URGENT – FIELD SAFETY NOTICE

Concerto & Basic shower trolley

Date:	2020-JAN-08
Product Issue:	Concerto & Basic shower trolley – Potential unintentional drop of safety side panel
Affected Product:	✓ Concerto & Basic shower trolleys manufactured between 2018-Oct-19 and 2018-Nov-07 Serial number ranges: P0513634 and P0515600
Affected Serial No.:	Attachment 3a rev. 2
Resolution:	Safety catches replacement in order to ensure the device is operating safely
Field Safety Notice:	FSN-POZ-002-2019 rev. 2
Pages:	3 & Customer Response Form

Image 1

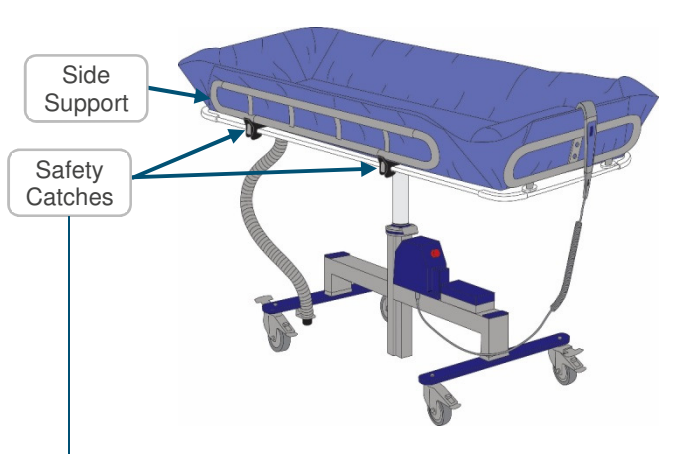
Each Concerto & Basic shower trolley is equipped with two Side Supports, one on each side of the shower trolley (Image 1). Each side support is secured by two (2) Safety Catches (Image 2) which are used to fold down the supports as well as secure the support in the raised position.

Image 2

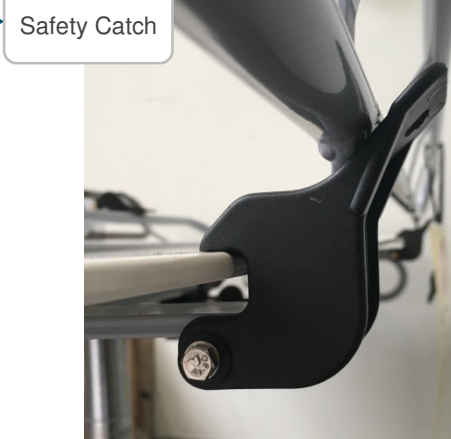
Arjo has become aware that there is likelihood that any of the 4 Safety Catch(es) may exhibit a mechanical failure (break in one of the arms of Safety Catch), which in certain circumstances may contribute to the Side Support unintentionally opening and may lead to a potential risk of patient fall, leading to possible injuries to patient and/or caregiver.

1. Verify the condition of all 4 Safety Catches attached to your device. If you notice the break (as shown in Image 3) withdraw the trolley from use.

- ✓ It is recommended that the Safety Catches on the shower trolley Side Supports be inspected daily to ensure any of the catches are not broken as show on the Image 3.
- ✓ The patient is not left unattended at any time.
- ✓ The patient is fully assisted so that he/she does not grab, push or lean against the Side Supports during showering activities.
- ✓ Caregivers should limit pulling and pushing of the Side Supports with excessive force.
- ✓ **Note:** always adhere to the Safe Working Load as outlined in the IFU.
